Supplement in Response to
Data Adequacy Comments
on the
Application for Certification
for the
Roseville Energy Park
Roseville, California
03-AFC-01

Submitted to the
California Energy Commission

Submitted by
Roseville Electric

December 2003

POWER FLOW DIAGRAMS

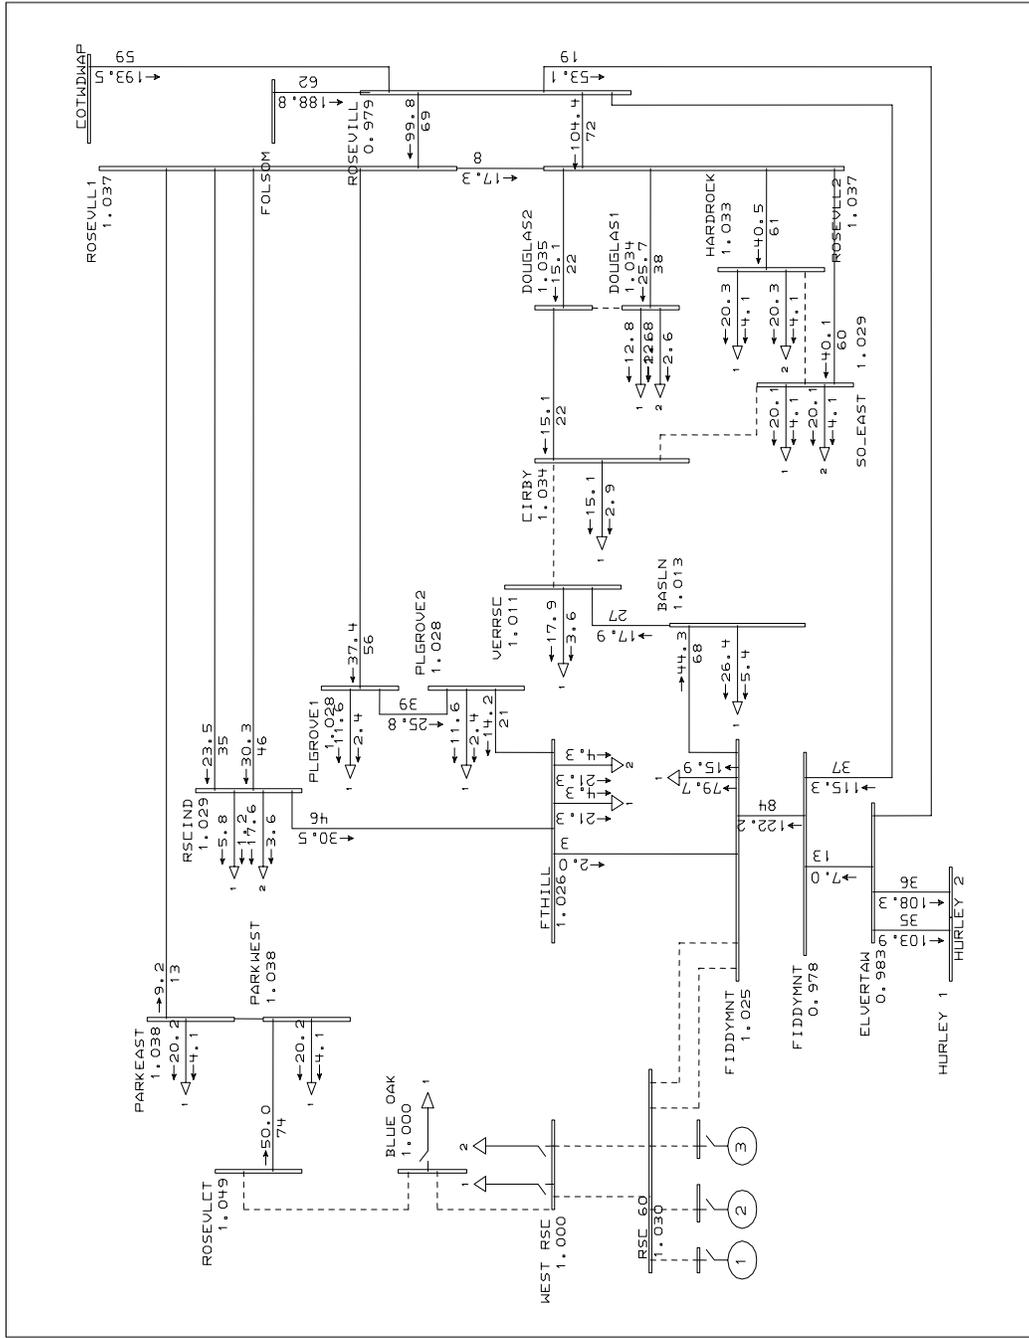
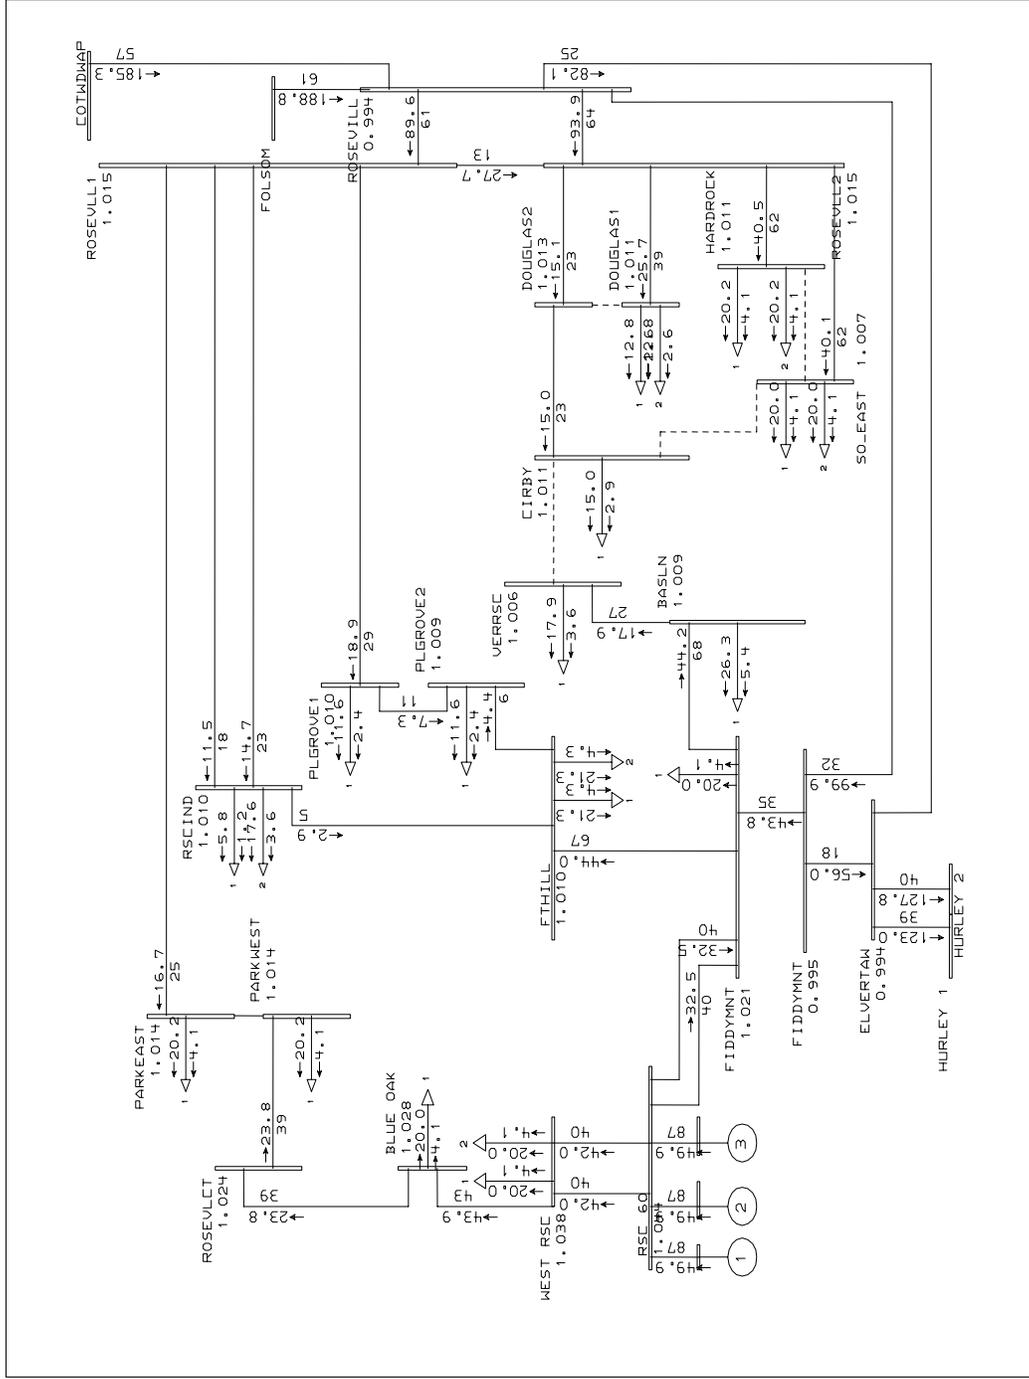
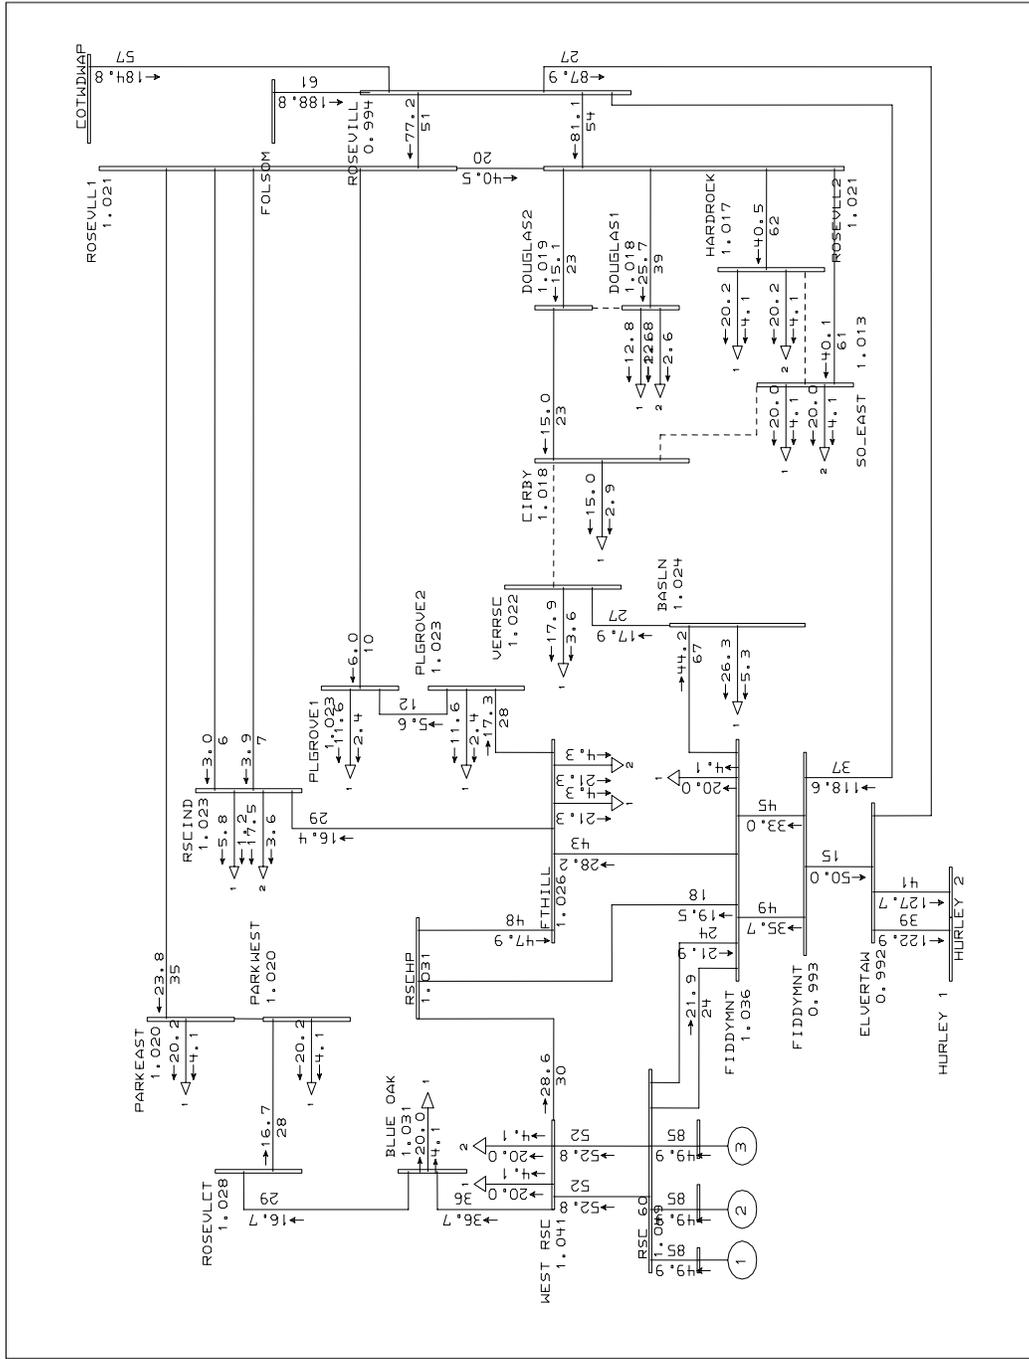
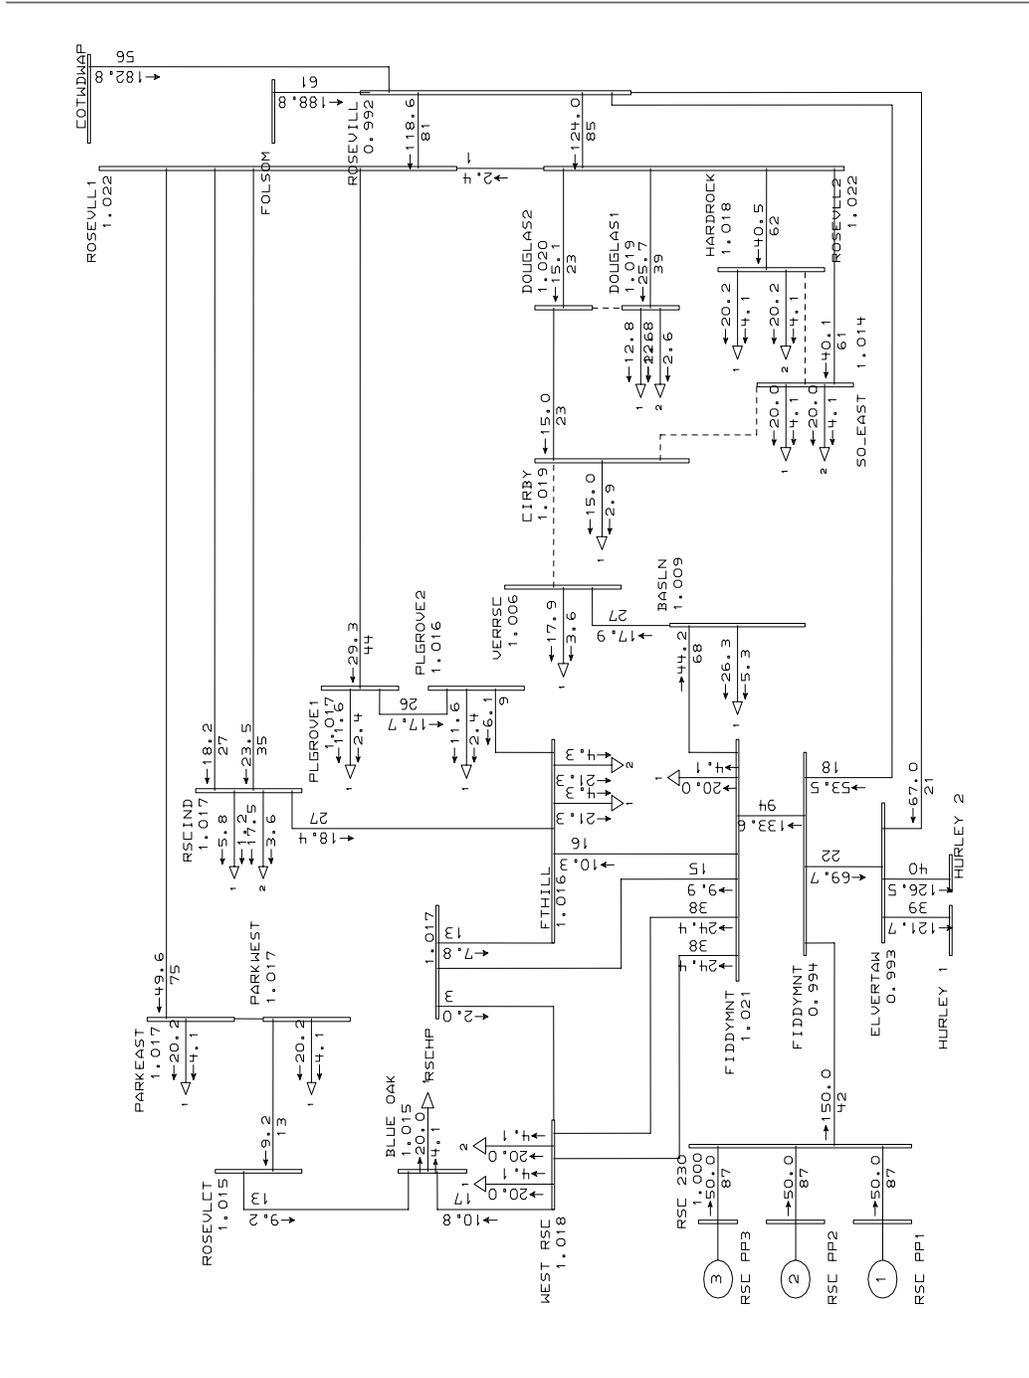
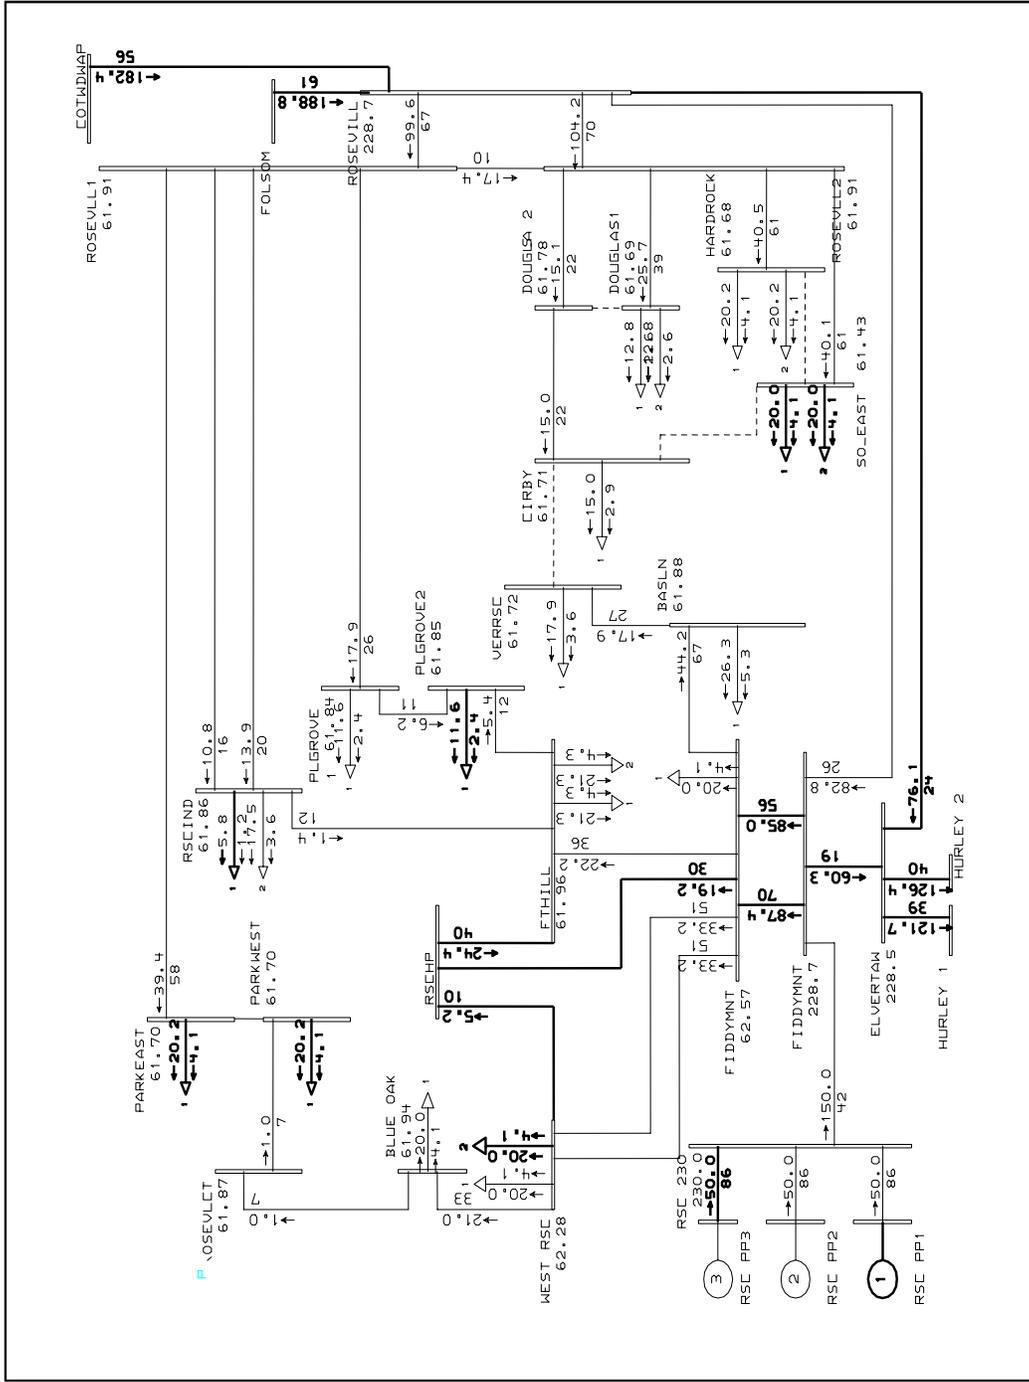
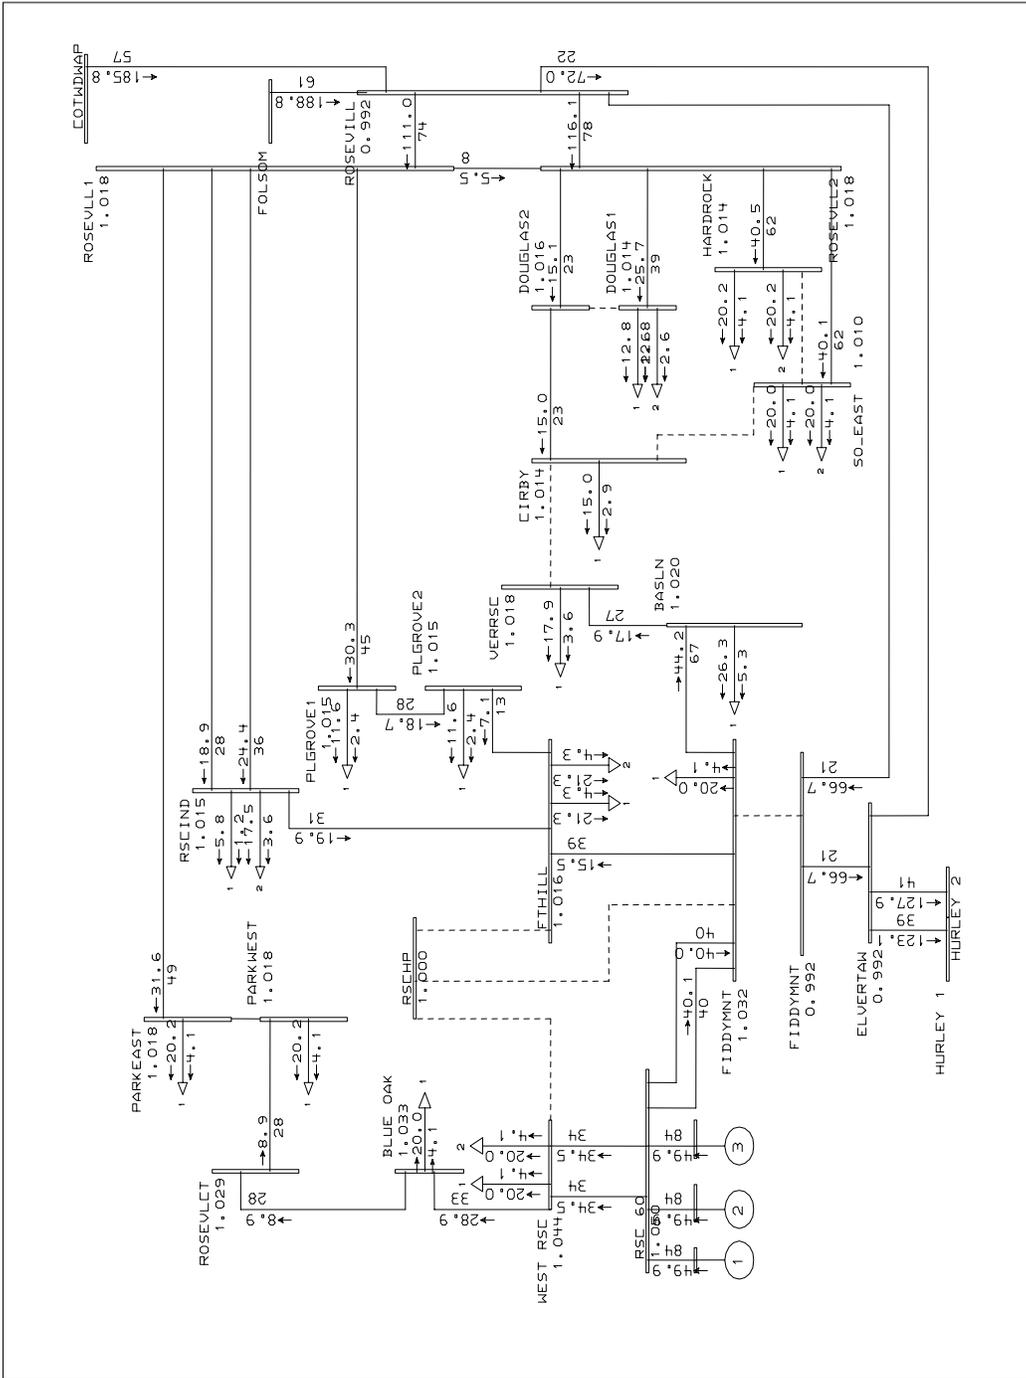
- h. *Provide power flow diagrams (MW, % loading and P.U. voltage) for post project overloads. Verify that figures 2 through 11 are under N-0 conditions.*

Power flow diagrams for post-project overloads are provided at the end of this section. These replace Figures 1-11 in the System Impact Study filed with the AFC and include MW, percent loading, and P.U. voltage. Figures 1-9 show N-0 conditions. Figure 10 shows the Elverta Bus Tie Breaker in open position and Figure 11 shows the Fiddymment Transformer in open position.

Figure 8.13-S1

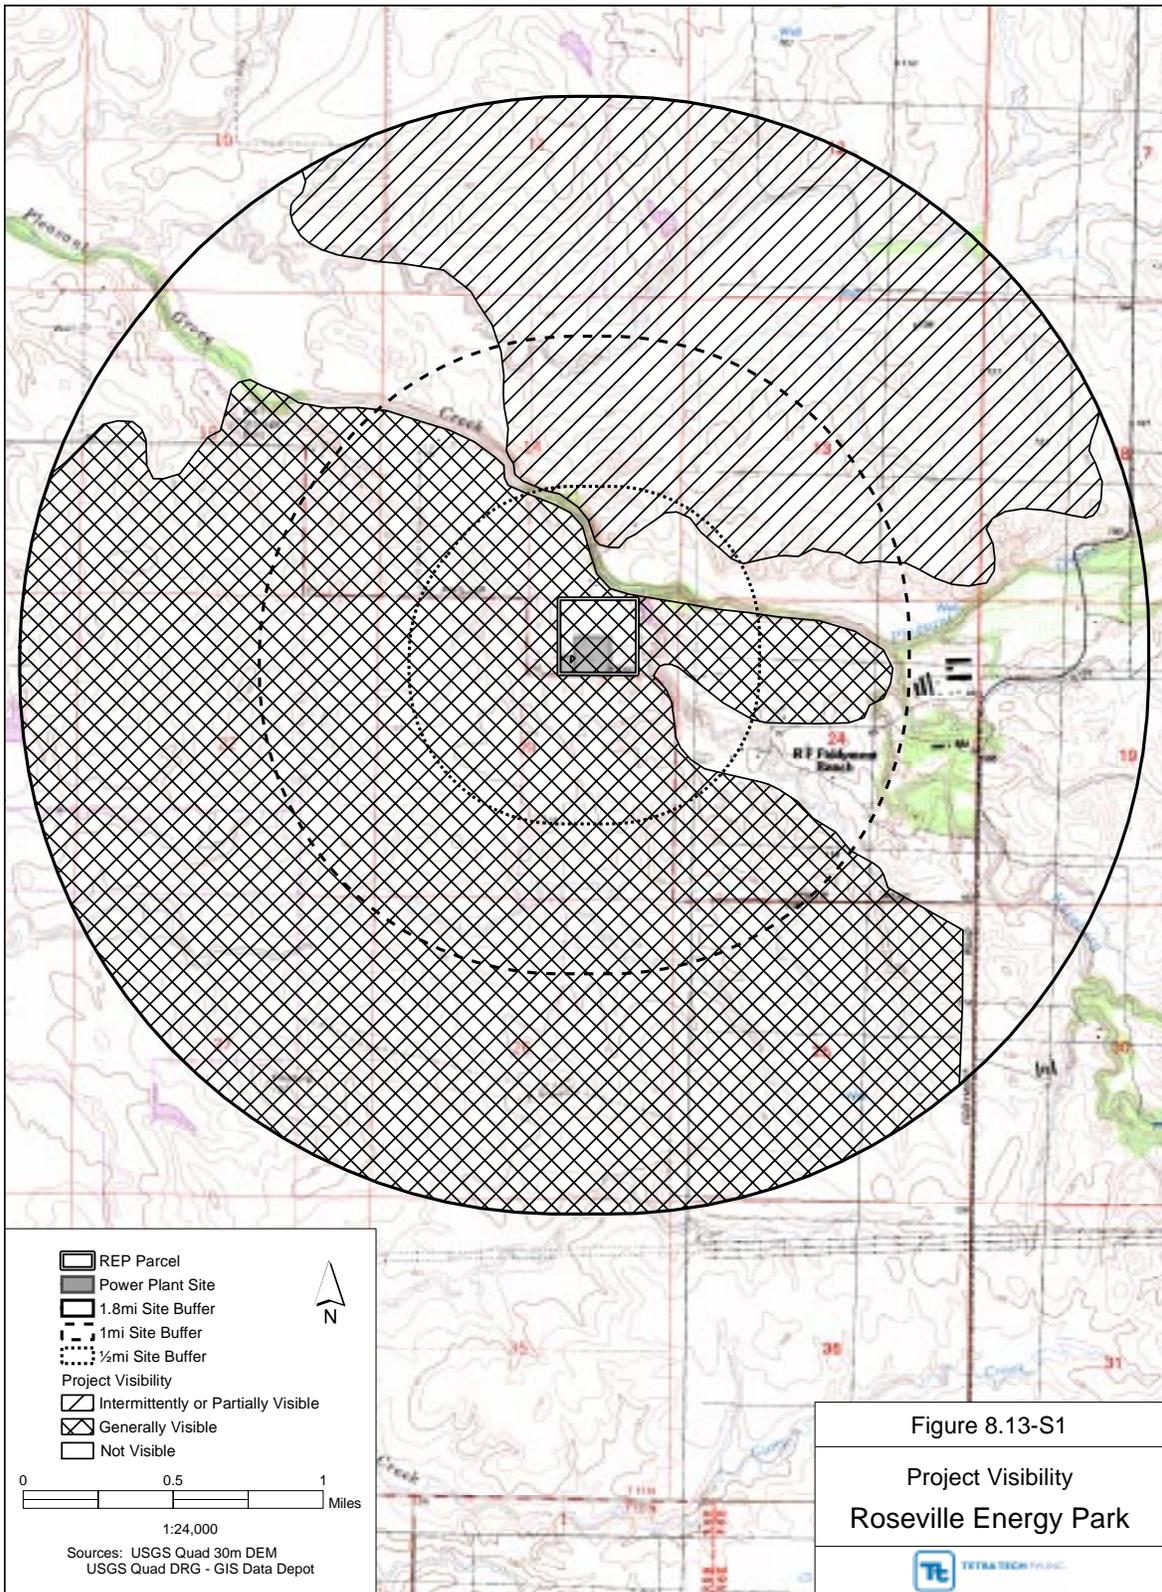
Please rescale Figure 8.13-1 at a scale of 1:24,000 (one inch equals 2,000 feet). Please also add to the legend what is meant by the undesignated (no hatch marks) areas within the "site buffer" zones on the Project Visibility map.

Response—Figure 8.13-S1 is a revised version of AFC Figure 8.13-1, at a scale of 1:24,000 and with the "project not visible" area labeled in the legend.
